AFFIDAVIT OF CORRECTION

To correct certain dimensions of Lots 2 and 4, and Southport Parkway Right-of-way and also Curve 1 in the Center-line Curve Table, Southport East (Lots 1 thru 16 inclusive and Outlot "A"), a subdivision located in the East 1/2 of Section 18, and also in the NW 1/4 of Section 17, all located in Township 14 North, Range 12 East of the 6th P.M., Sarpy County, Nebraska.

AFFIDAVIT OF CORRECTION
 LOTS 2 AND 4, AND SOUTHPORT PARKWAY RIGHT-OF-WAY,
 SOUTHPORT EAST
 (LOTS 1 THRU 16 INCLUSIVE AND OUTLOT "A")
 SARPY COUNTY, NEBRASKA

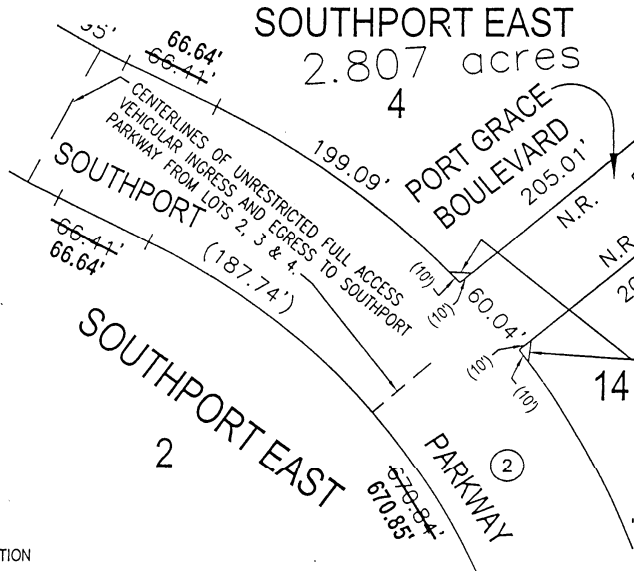
- The Northeastly line of said Lot 2 to read 66.64 feet instead of 66.41 feet.
- The Southwestly Right-of-way line of Southport Parkway to read 66.64 feet instead of 66.41 feet.
- The Northeastly line of said Lot 2 to read 670.85 feet instead of 670.84 feet.
- The Southwestly Right-of-way line of said Southport Parkway to read 670.85 feet instead of 670.84 feet.
- The Southwestly line of said Lot 4 to read 66.64 feet instead of 66.41 feet.
- The Northeastly Right-of-way line of said Southport Parkway to read 66.64 feet instead of 66.41 feet.
- The Curve 1 in said Center-line Curve Table to read Radius - 549.50 feet, Length - 316.08 feet, Tangent - 162.55 feet, Delta - 32°57'26" instead of Radius - 549.32 feet, Length - 316.79 feet, Tangent - 162.39 feet, Delta - 32°56'15".

I Robert V. Clark, do hereby submit the above drawing in order to correct error in dimensions of Lots 2 and 4, and Southport Parkway Right-of-way and also Curve 1 in the Center-line Curve Table, Southport East (Lots 1 thru 16 inclusive and Outlot "A"), a subdivision located in Sarpy County, Nebraska as recorded in Instrument No. 2001-30162, in the Register of Deeds Office, Sarpy County, Nebraska.

CURVE 1 549.50' 316.08' 162.55' 32°57'26"
